DESIGN RECOMMENDATION MEETING

JANUARY 2014
800 NE 67TH ST
68TH + 8TH MULTIFAMILY HOUSING

DPD PROJECT #3014586

A-1 RESPONDING TO SITE CHARACTERISTICS

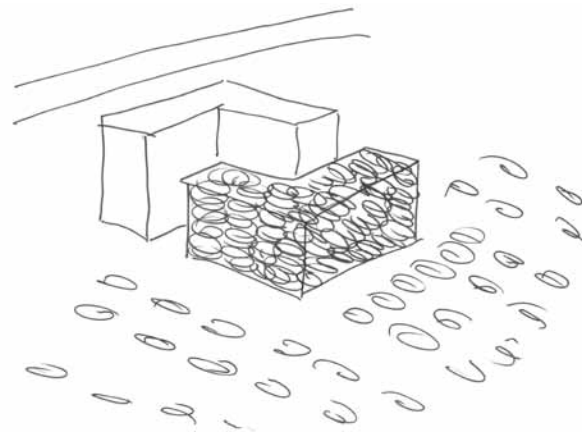
The board acknowledged that the stepped floor and unit plans successfully responded to the steep site. They preferred the massing of Option C, with the courtyard oriented to capture afternoon sun and the west building serving to block the majority of highway noise. The board agreed that any vehicle access should be located on 8th Avenue.

The general massing and form of the building responds to the site by taking the form of two L-shaped buildings, The west building relates to the scale of the freeway and features a prominent horizontal roof form that reflects the horizontality of the I-5 bridge immediately to the SW of the site.

In contrast, the east building is the more grounded building and features modulation that steps down in relation to the existing low-rise residential buildings to the east of the project site.

A courtyard is created between the two "L"s that maximizes the amount of sunlight to penetrate the site and creates an urban oasis for the residential tenants. A series of steps will connect residents from NE 67th St to NE 68th St via the courtyard. To mitigate the approximately 40' grade change across the site, a series of swales and planters address the transition from the sidewalk to the face of the building. The swales will direct water to a rain-garden at the base of the residential lobby to further enhance the connection between the flow of water around and across the site and the residential circulation around the site.

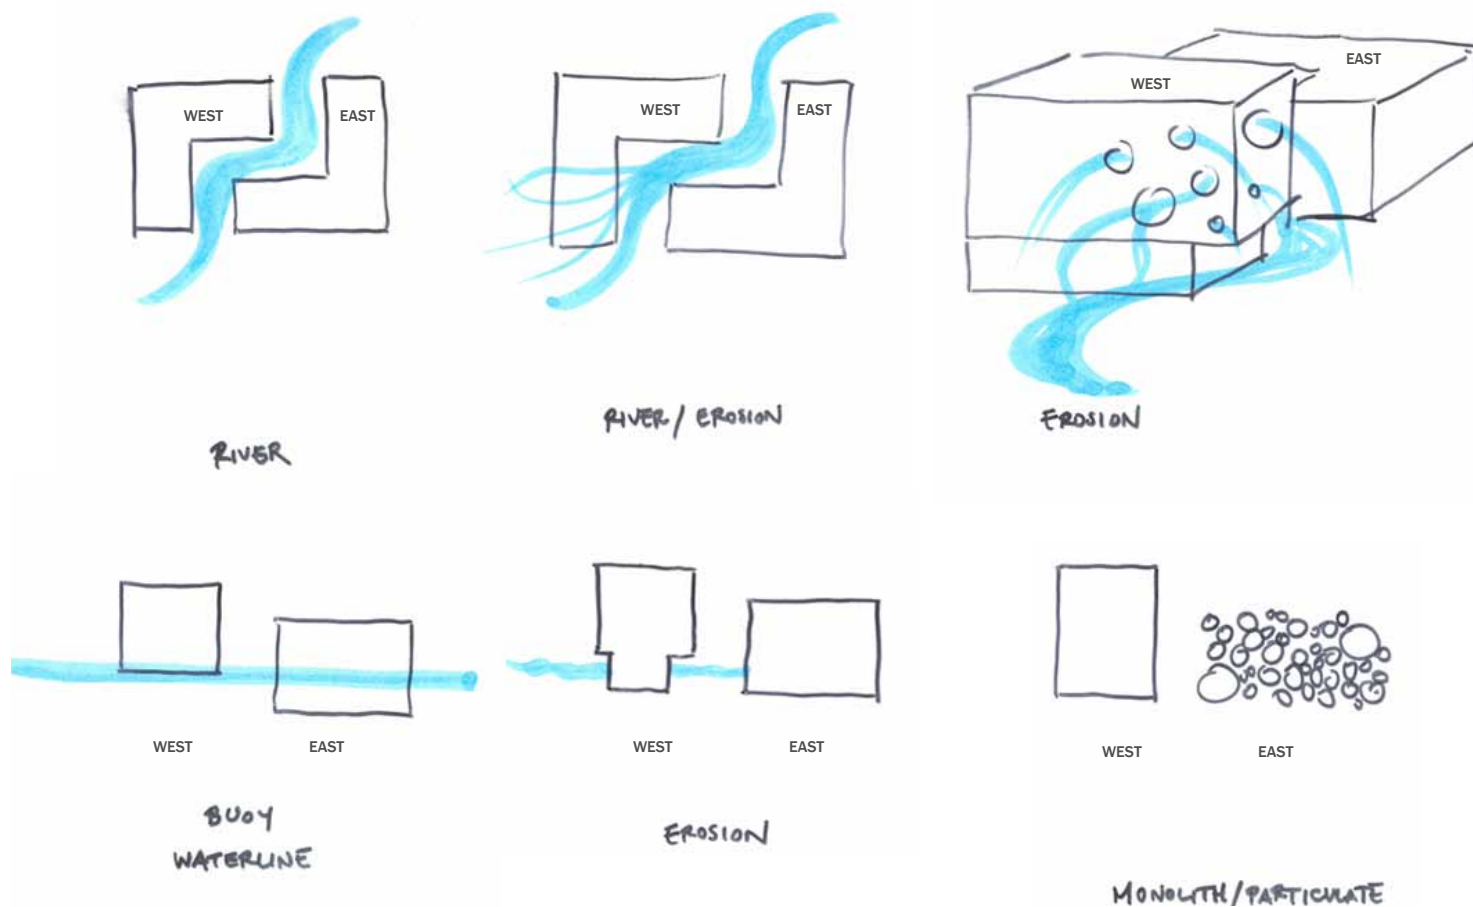
The board discussed the site-specific sloped edges and possible methods for mitigating any freeway noise while maintaining westerly views, especially at the roof deck; perhaps utilizing glass screens at this location.

DEPARTURE REQUESTS
DEPARTURE #1 DIAGRAM

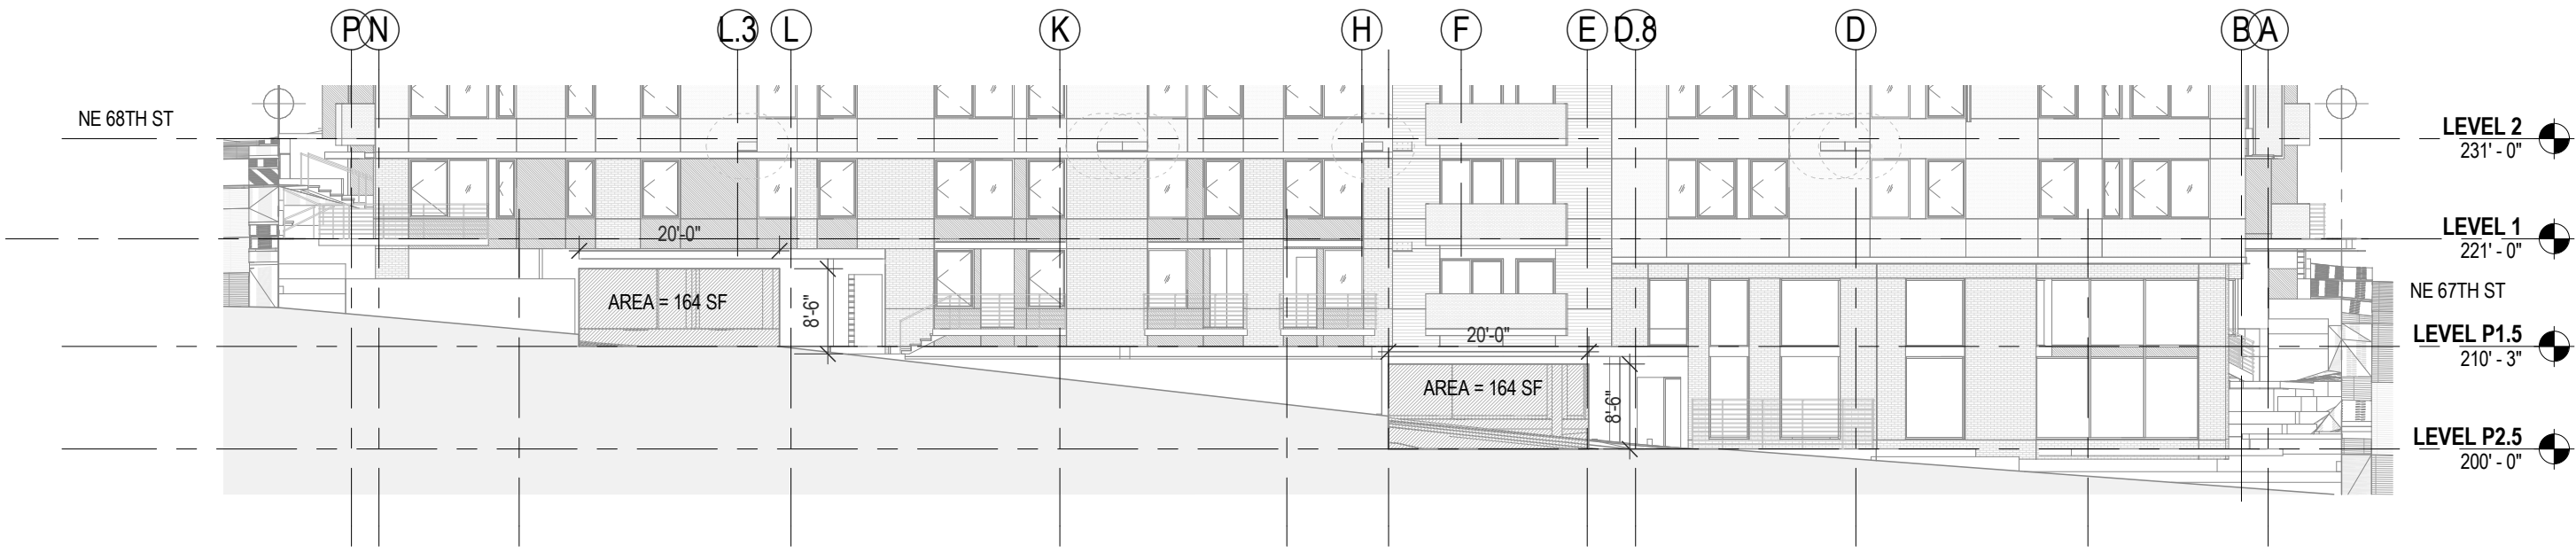
Parking shall be screened from view
 If screened by garage door facing street, then max 75 sq. ft. of garage door
 AND doors must be min 15' from street lot line
 Door size Provided: 164 sf ea. See T0.3
 Distance Provided: 32' & 35' See A0.1

West elevation close up showing proposed size of garage doors at levels P1 and P2 residential garage entrances.

DEPARTURE REQUESTS DEPARTURE #2 DIAGRAM

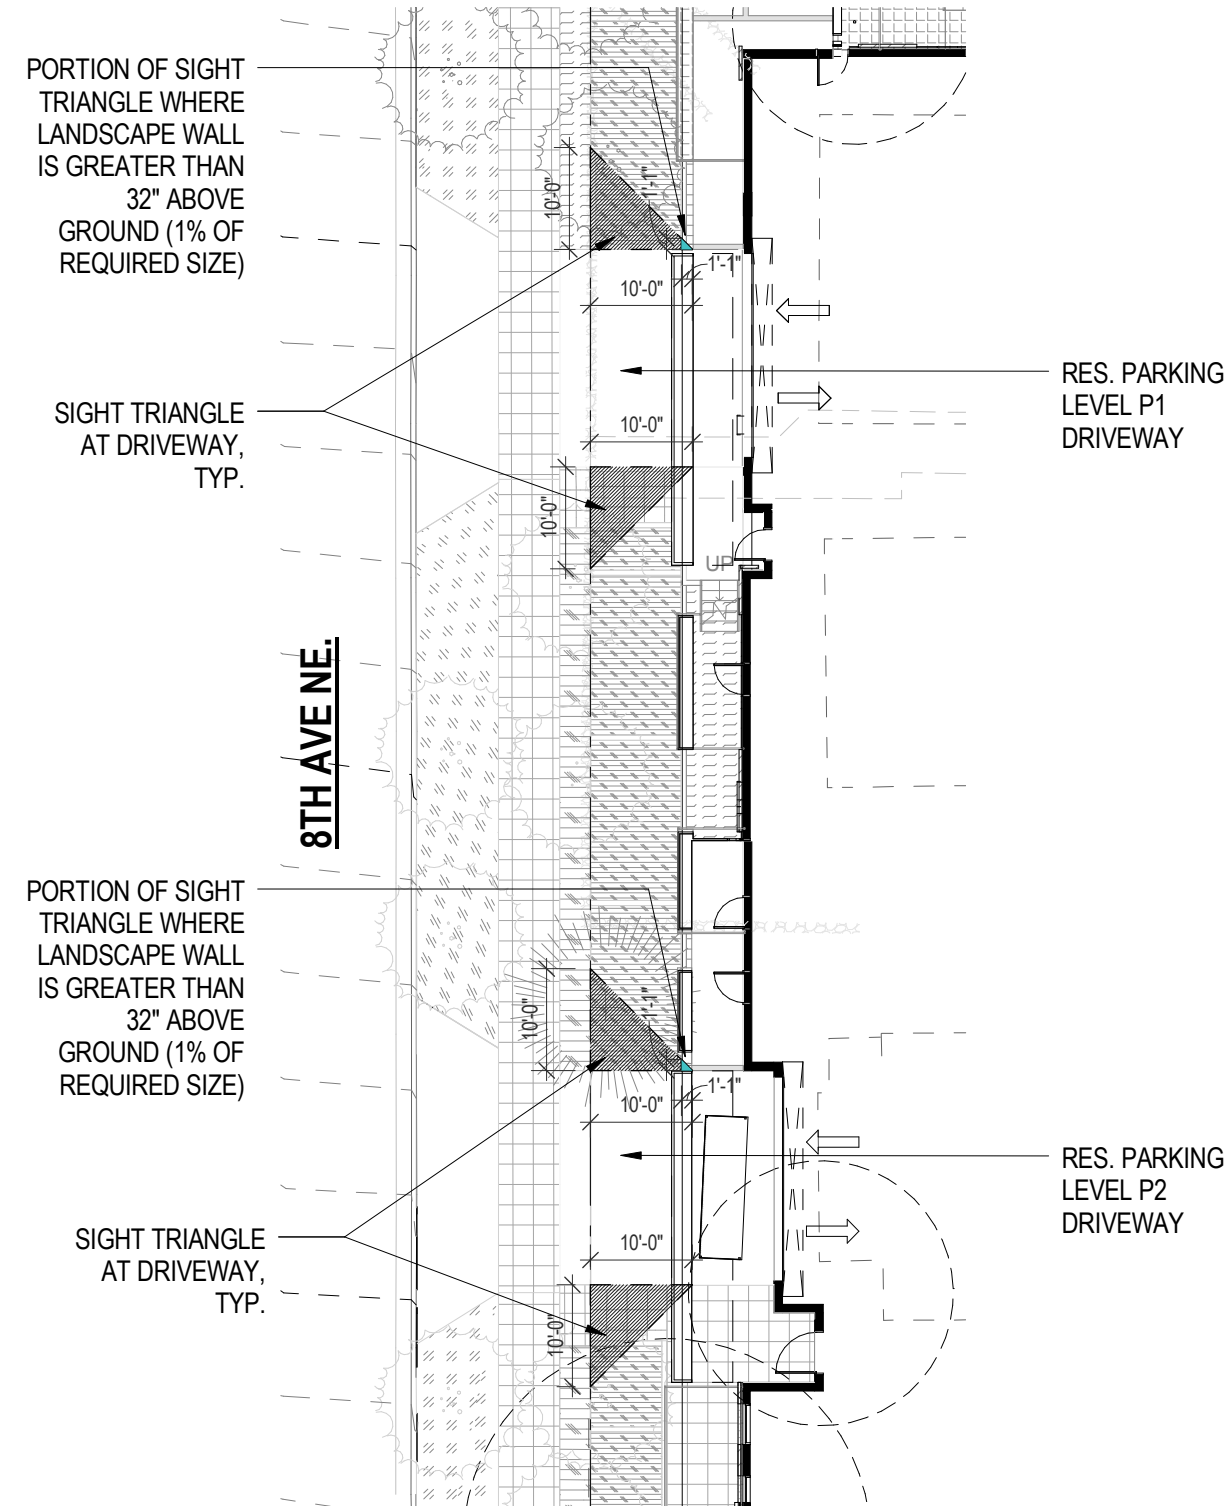
REQUIREMENT	REQUEST	JUSTIFICATION	DRB COMMENTS
<p>SIGHT TRIANGLE SMC 23.54.030.G 3</p> <p>THE SIGHT TRIANGLE IS TO BE KEPT CLEAR OF OBSTRUCTIONS IN THE VERTICAL SPACES BETWEEN 32" AND 82" FROM THE GROUND.</p>	<p>REQUEST THAT A PORTION OF THE LANDSCAPING RETAINING WALL ENCROACHING INTO THE SIGHT TRIANGLE.</p>	<p>THE ENCROACHMENT IS ONLY 1% OF THE REQUIRED SIZE OF THE SIGHT TRIANGLE AND OCCURS DUE TO THE STEEP GRADE CONDITION OF THE SITE. THE LANDSCAPE PLANTER WALLS SERVE TO SOFTEN THE TRANSITION FROM THE SIDEWALK GRADE TO THE FACE OF THE BUILDING. THE WIDTH OF THE DRIVEWAY IS LARGER THAN THE MIN. WIDTH REQUIRED BY CODE. THE SIGHT TRIANGLE WOULD BE CODE COMPLIANT IF THE DRIVEWAY WERE 20' WIDE.</p>	<p>None – This aspect of the design was not developed enough to know the need for this departure at the time of the EDG.</p>

Site plan close up showing sight triangles and where the encroachment occurs.
